SITE PLAN REVIEW

Project Name: GULLIKSON TRUCKS

TITLE HEADING: Site Plan Review - Gullikson Heavy
Truck and Equipment Sales

PREPARED FOR
BRUCE GULLIKSON
SITE PLAN
GULLIKSON HEAVY TRUCK
AND EQUIPMENT SALES
2224 SANFORD DRIVE
GRAND JUNCTION, COLORADO

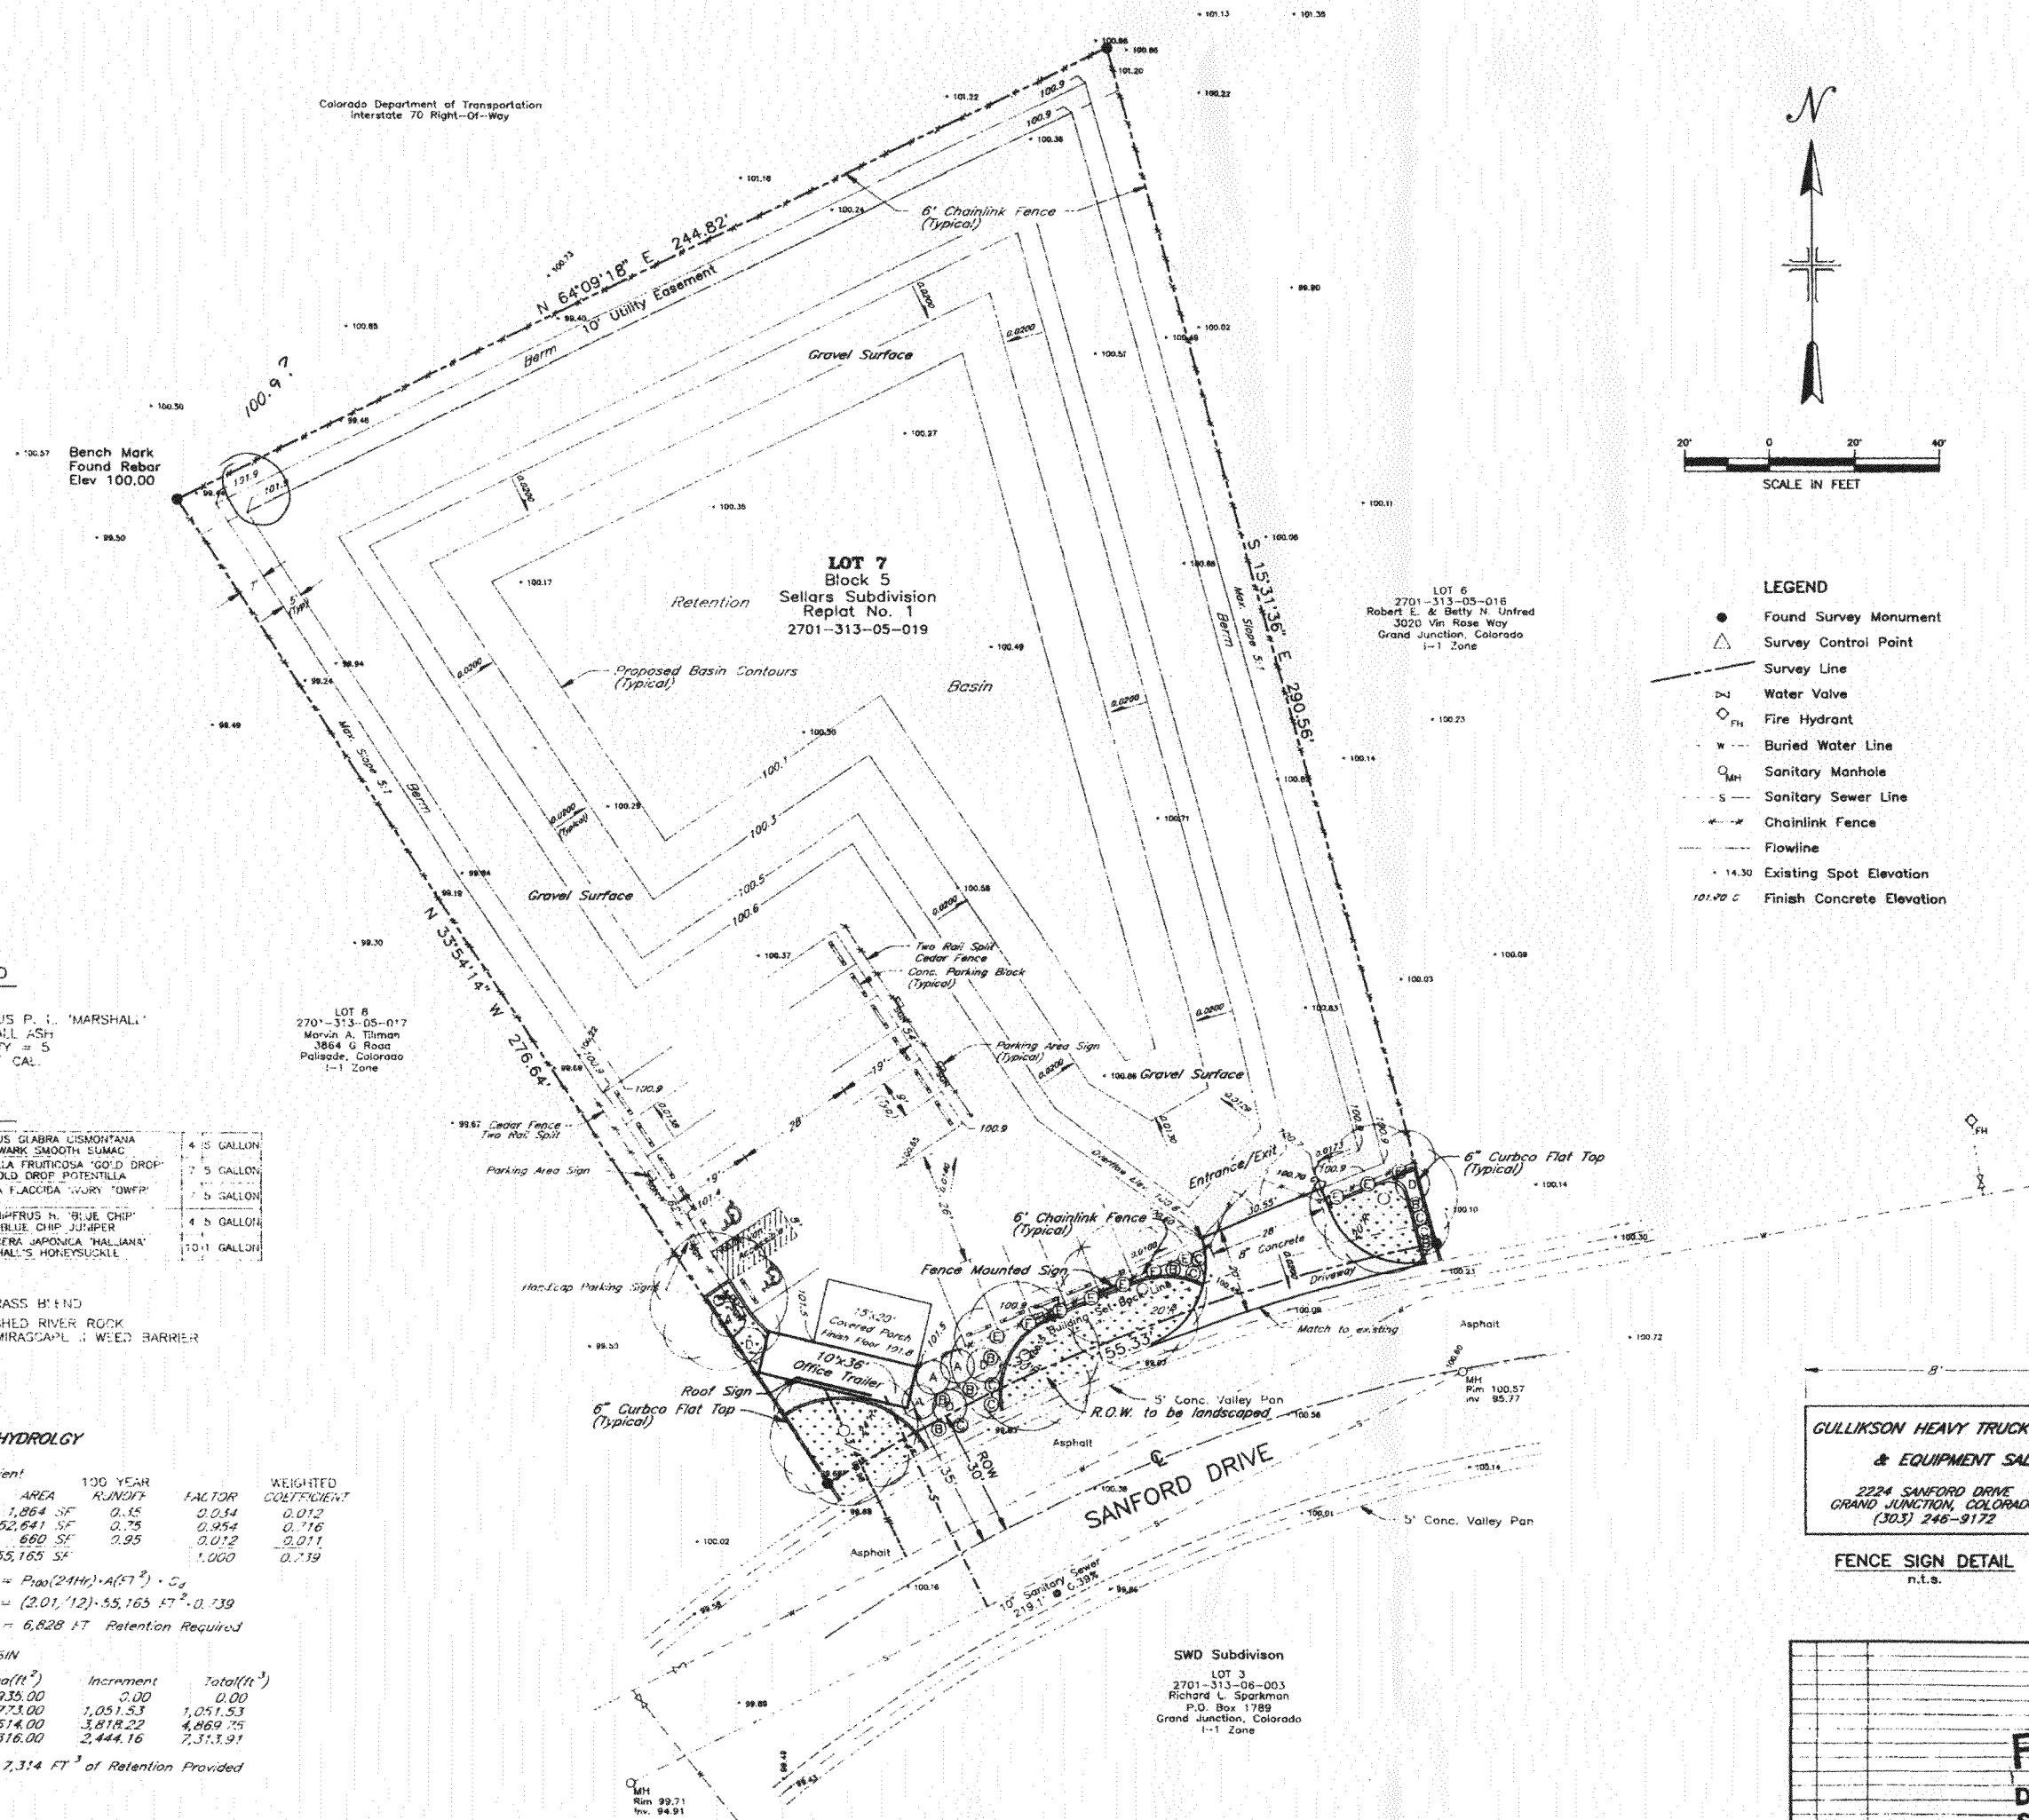
1. Either detention or retention is required, or, if the ordinance passes, a drainage fee in lieu of may be acceptable. Note that most of the site will be changed from an "undeveloped area" to having "gravel and soil traffic area". See Appendix B of the Drainage Manual.

2. To help minimize the tracking of gravel onto the street, the driveway shall be paved with concrete. Show and call it out, and add it to the Improvements Agreement.

Good use of lot. If possible could they be required to pave the driveway area and provide a paved area where gravel from the lot is not tracked onto the street pavement. How are the parking places going to be marked? How are the handicap spaces going to be used on a gravel surface?

1. The amount of landscaped area and type and size of landscaping meets the Zoning and Development Code requirement except the amount of shrub area provided. A suggestion would be to plant some trees along the Interstate 70 frontage for aesthetic treatment especially since approximately one-half of the landscaping requirement is calculated from the I-70 frontage and none is proposed there. The Zoning and Development Code allows staff to vary the size of the shrub area requirement if shade trees are provided in excess of the minimum requirement. Please revise the landscaping plan to incorporate minimum shrub area requirements (719 sq ft) or a proposal for a variance to the shrub area. The landscaping costs do not have to be guaranteed through the improvements guarantee unless a certificate of occupancy is needed prior to installation of the landscaping.

4. The amount of parking as shown is adequate. Parking blocks or some other acceptable method of delineating parking spaces are required.

Retention is the method chosen for the excess runoff created by development and the site plan has been revised to reflect the proposed retention basin. A concrete driveway will be constructed as shown on the plan and has been added to the Improvements Agreement.

Parking spaces will be delineated with concrete parking blocks and decorative fencing. The hard packed road base (Class 4 or Class 5) will provide minimal restriction to disabled people, in particular those wishing to buy a semi-truck or large piece of construction equipment.

Landscape plan has been revised to increase shrub area. Adequate landscaping will be installed as per City requirements. The landscaping will be installed after the permit of occupancy is needed.

All necessary permits for fencing and signage will be acquired. Parking blocks will be installed as shown on the revised plan. Fire flow is adequate.
